SHOP DRAWING REVIEW

☐ REJECTED ☒ REVISE AND RESUBMIT ☐ FURNISH AS CORRECTED

Project: BRF 0162 VT RTE 73 & 100 ROCHESTER, VT

Drawing: BR #19 ABUT. #1 & WINGWALL REINF

ABUTMENT 1 ELEVATION

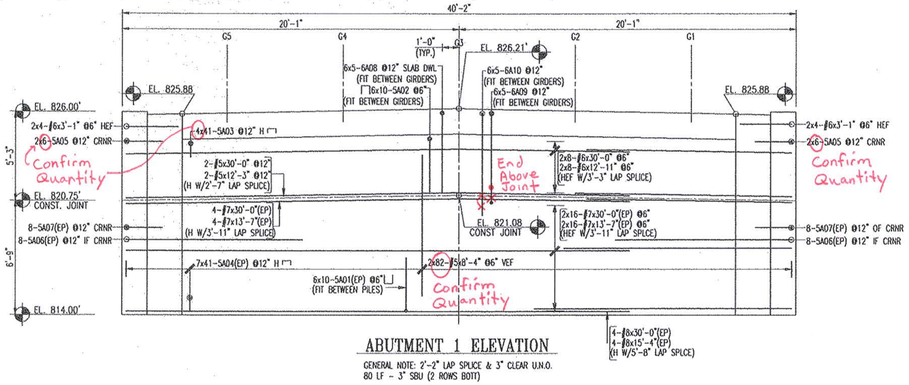
Confirm Length

#10 & #5 Foundation Starter Bars

Confirm Quantity

5A22 Leg Length of 2'-8" may not fit @ this end

#5 Bar Sloped Along top of Wall

Show Corner Bars

Increments

Missing Info

Show Bar Length Increments

#10

Center Bridge Seat Bars

WINGWALL 1 ELEVATION

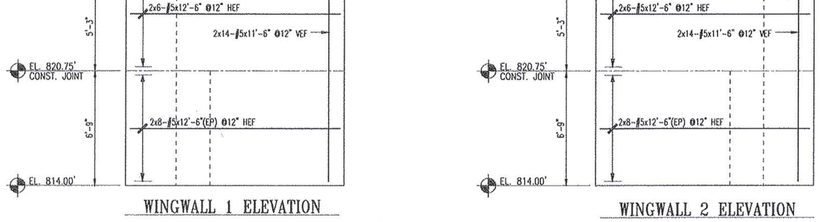
Missing Info

Show Corner Bars

#5 Bar Sloped Along top of wall

Increments
